HIGHWAYS ACT 1980 SECTION 119  
Gateshead Metropolitan Borough Council  
Public Path Diversion Order Footpath Blaydon 11 (Part) Diversion Order 2015

## Order Decision

**Order Ref: FPS/H4505/4/6**

- This Order is made under Section 119 of the Highways Act 1980 (the 1980 Act) and is known as the **Footpath Blaydon 11 (part) Diversion Order 2015**.
  - The Order is dated 13 January 2015 and proposes to divert part of Footpath 11 at Newhouse Farm, Chopwell, Gateshead as shown on the Order map and described in the schedule.
  - There was one objection outstanding when the Borough Council of Gateshead (the Council) submitted the Order for confirmation, subject to modifications, to the Secretary of State for Environment, Food and Rural Affairs.
-

**Footpath Blaydon No. 11 Part Diversion Plan  
 Newhouse Farm, Chopwell.**

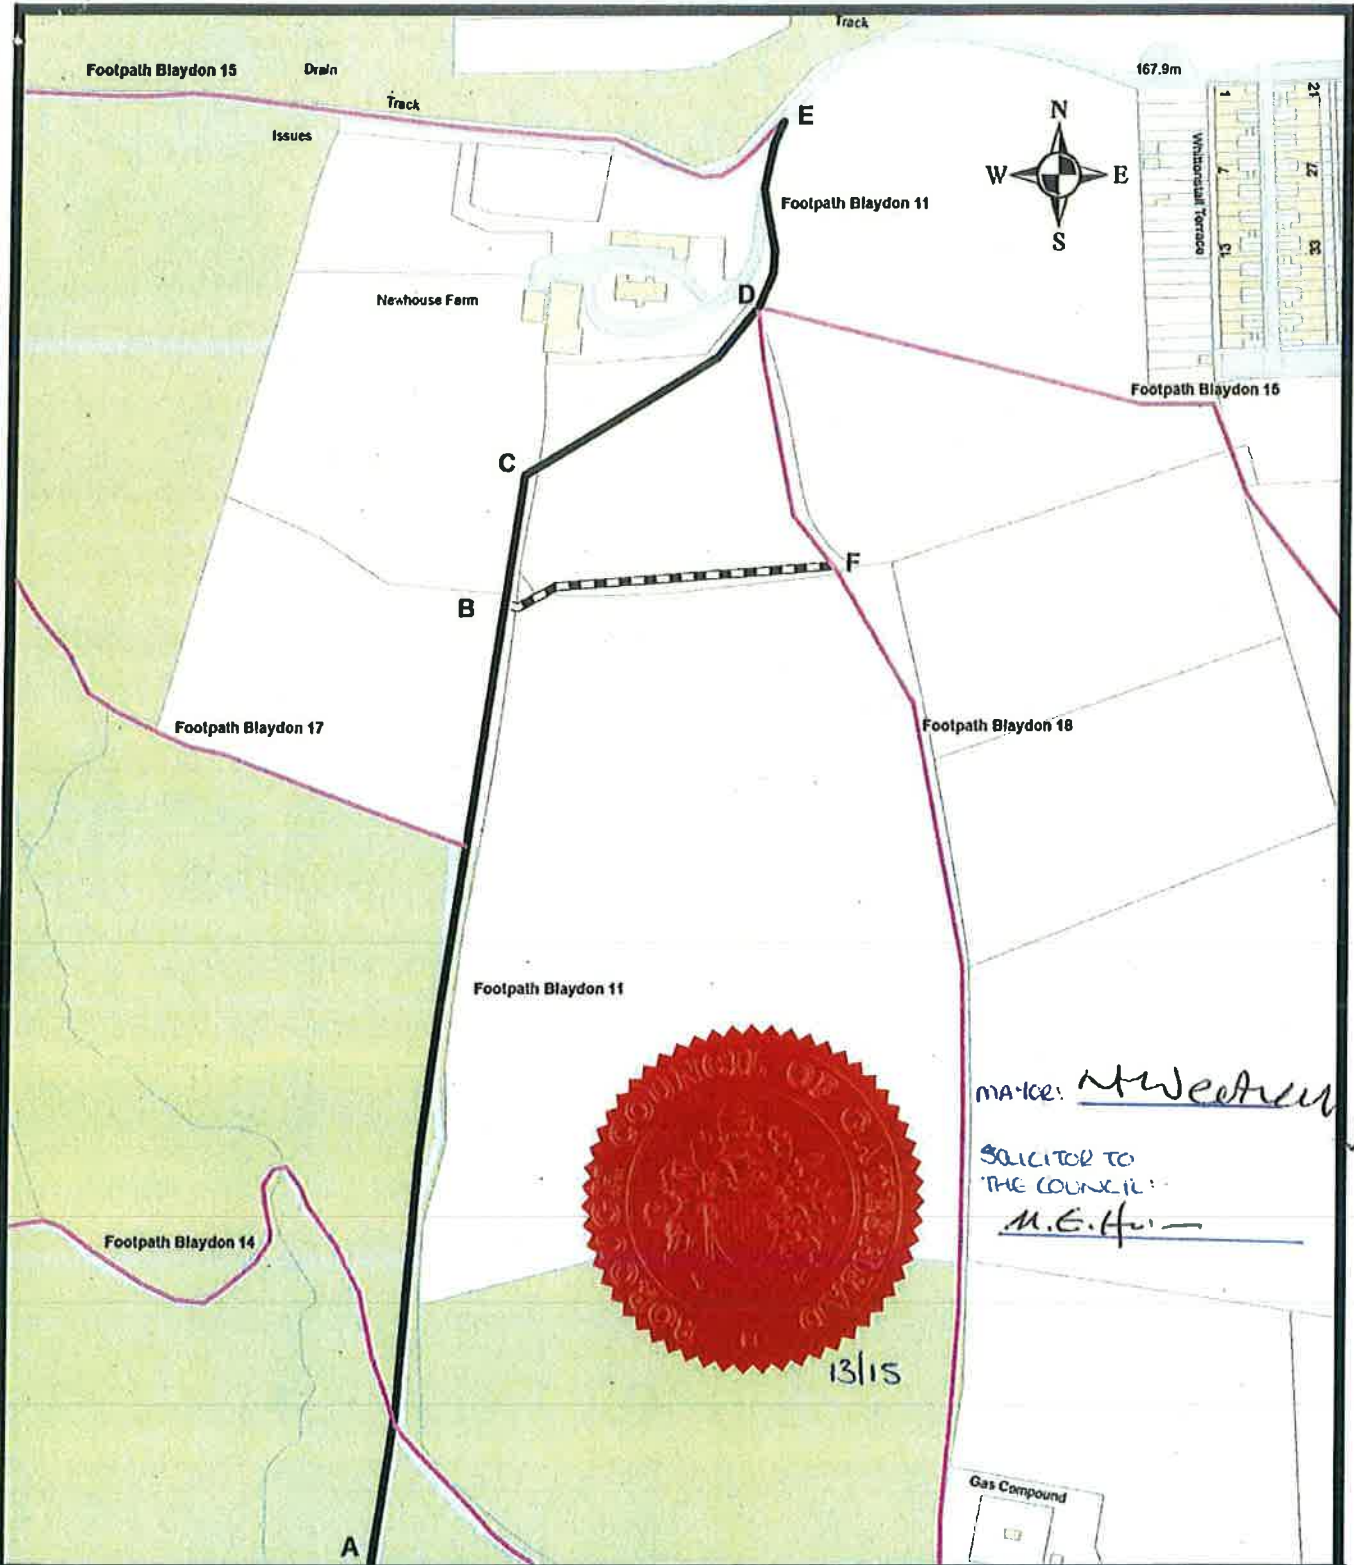
2. Following an application from the owner of Newhouse Farm, Chopwell the Council made the Order. Before making the Order the Authority carried out consultations and no objections or representations were received. After the publication of the Order one objection was made on the ground that no design standard is detailed for the two stiles that are proposed to be constructed across the diverted footpath.

3. The Council agrees that a specification for the stiles is required and has therefore submitted the Order to the Secretary of State seeking confirmation of the Order with modifications to the limitations and conditions. I agree that a design specification is appropriate and I have therefore modified the Council's Order in accordance with its request.

In the description column of Part 3 of the Schedule delete the existing text and insert:

for Grid Reference NZ11145818 'Wooden wide-post and rail stile approved by the Borough Council of Gateshead as being in accordance with all relevant current legislation and guidance including BS5709:2006 at Point B on the Order map.' and

for Grid Reference NZ11155818 'Wooden wide-post and rail stile approved by the Borough Council of Gateshead as being in accordance with all relevant current legislation and guidance including BS5709:2006, near Point B on the Order map.'
